WOODROW WILSON BRIDGE REPLACEMENT
PRELIMINARY DESIGN PLANS FOR JONES POINT PARK, URBAN DECK AT WASHINGTON
STREET (GEORGE WASHINGTON MEMORIAL PARKWAY), AND POTOMAC RIVER
WATERFRONT COMMUNITY PARK
City of Alexandria, Virginia and Prince George's County, Maryland

Report to the Federal Highway Administration and the National Park Service

March 1, 2001

DECK-OVER SECTION DETAIL SHOWING “GATEWAY SENTINEL” ELEMENT LOCATION

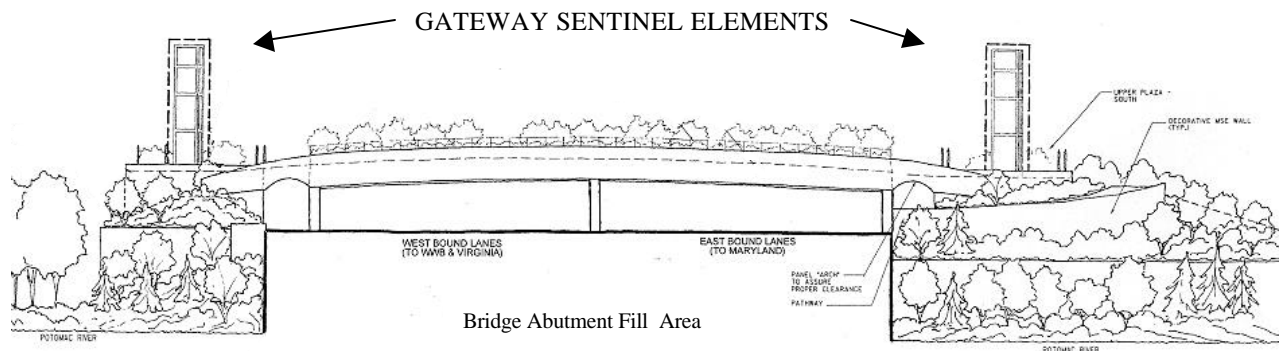
Given the above efforts and results, the staff nevertheless recognizes and expresses concern over particular elements of the submitted preliminary plans. Primarily, this concern is directed at the Potomac River Community Park design involving the vertical “gateway sentinels” feature of the park design. Commission staff had cautioned FHWA in the early consultation meeting that the vertical elements required a design dialog that emanates from the vocabulary of the bridge design and is a feature “of the bridge.” It is apparent that little progress has been achieved on that aspect of the park. Accordingly staff believes that in the preliminary design of the gateway sentinel elements, a design should be pursued that: limits its height impact as seen from bridge deck views; that is compatible in its lighting design with the main bridge; and exhibits a form harmonious with the overall bridge in material and composition. Consequently, the staff recommends only conceptually accepting the provision of a gateway feature at this time.
